D/DRC Case

1221-1301 Huger Street & 401-433 Gervais Street

DESIGN/DEVELOPMENT REVIEW COMMISSION
DESIGN REVIEW DISTRICT
EVALUATION SHEET
Informational Presentation

DESIGN/DEVELOPMENT REVIEW COMMISSION
CONCEPTUAL SITE/SUBDIVISION PLAN
REVIEWING AGENCY COMMENTS

BUILDING TWO - LEVEL 01

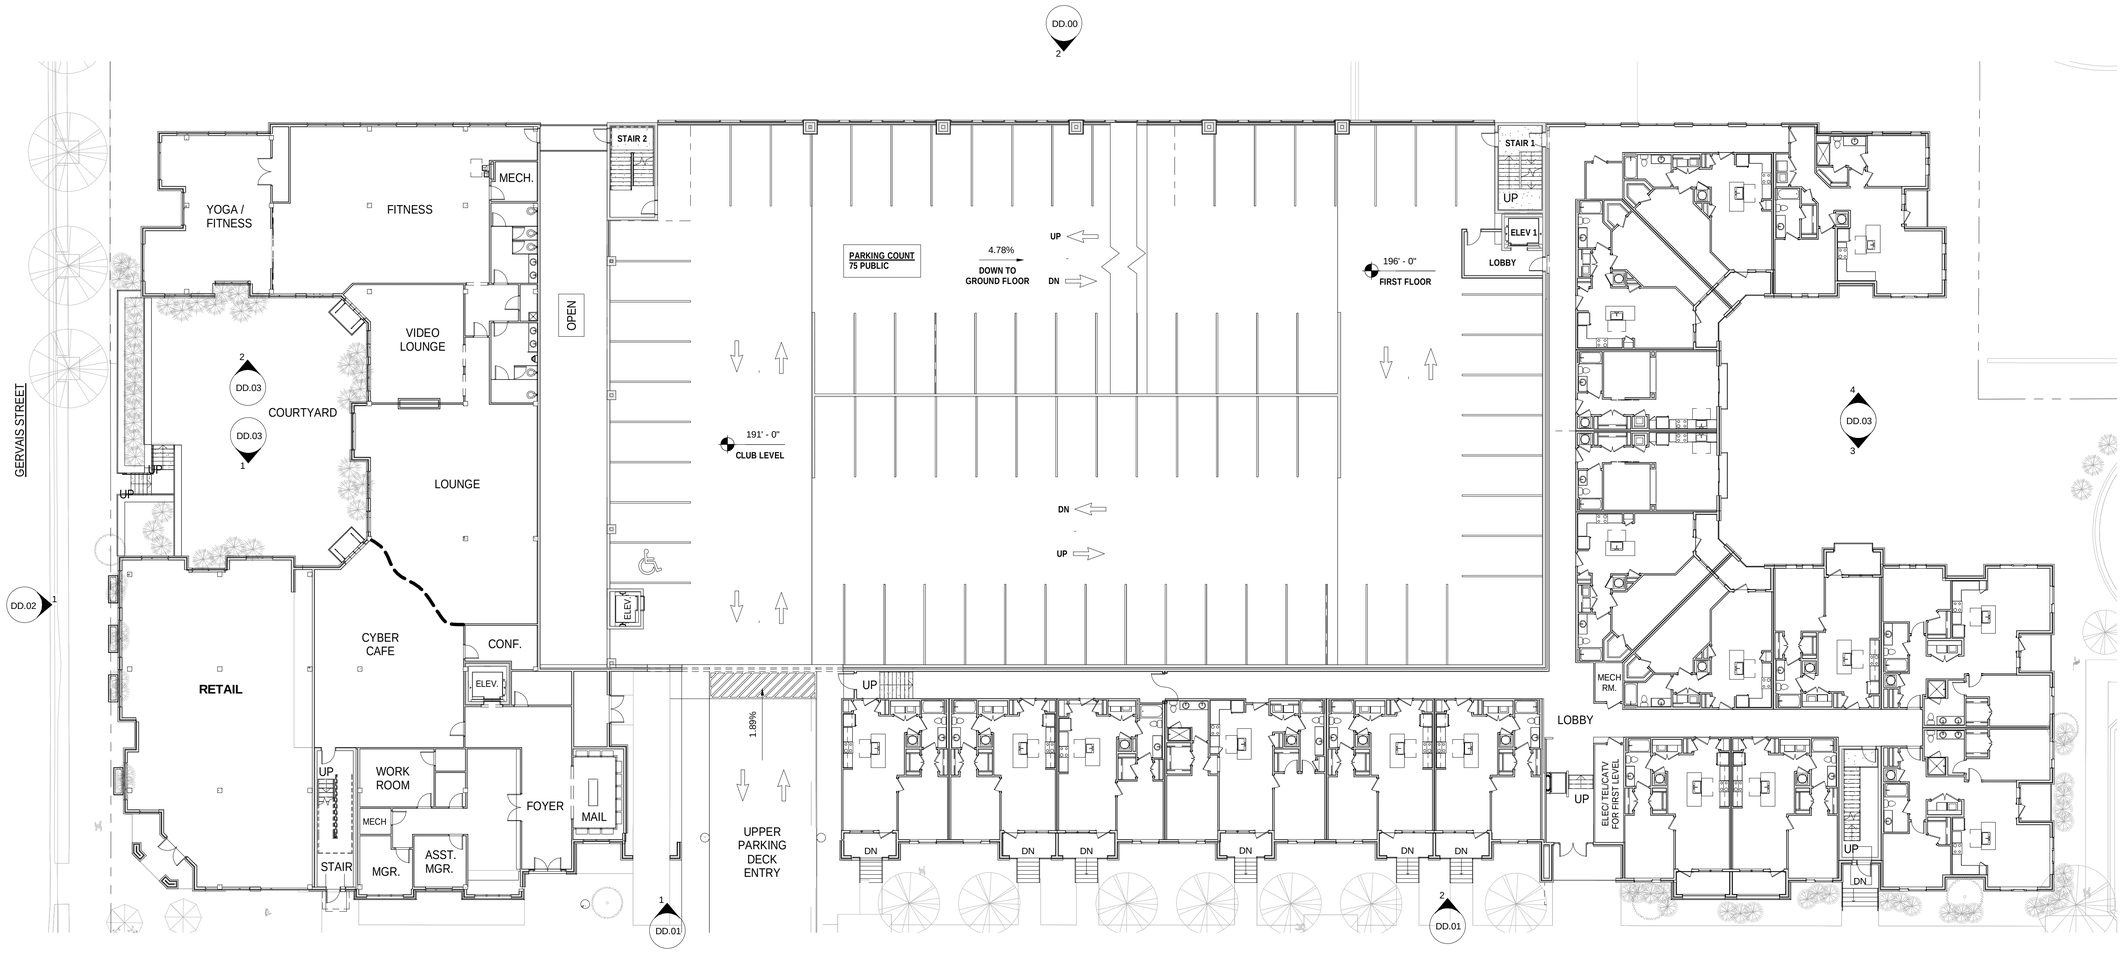
Building Two generally needs more street-level detailing, and architectural elements to add interest to the façade. The Gervais Street elevation has blank walls for nearly 100 feet, with windows and courtyard about nine feet above the street level. A terraced planter has been added in front of the residential courtyard, which helps mitigate the height of the wall, but overall more detailing is needed. The canopies on this end are 25 feet above the sidewalk. Similarly, on the retail end the storefront is largely flat and unarticulated, and the western-most canopy is nearly 20 feet above the sidewalk, which seems too high to create a sense of human scale.

Building Two has a retail space on the Gervais Street corner. The Gervais Street façade, which is the primary façade, is about 40% retail frontage, 35% courtyard, and 25% yoga studio. However the finished floor elevation of the yoga studio is 6-8 feet above the sidewalk, creating a pedestrian experience of a blank wall. The grade change on this site is dramatic, making the street frontage requirements more difficult to achieve, however creative architectural solutions need to be pursued to mitigate blank walls in addition to using landscape screening.
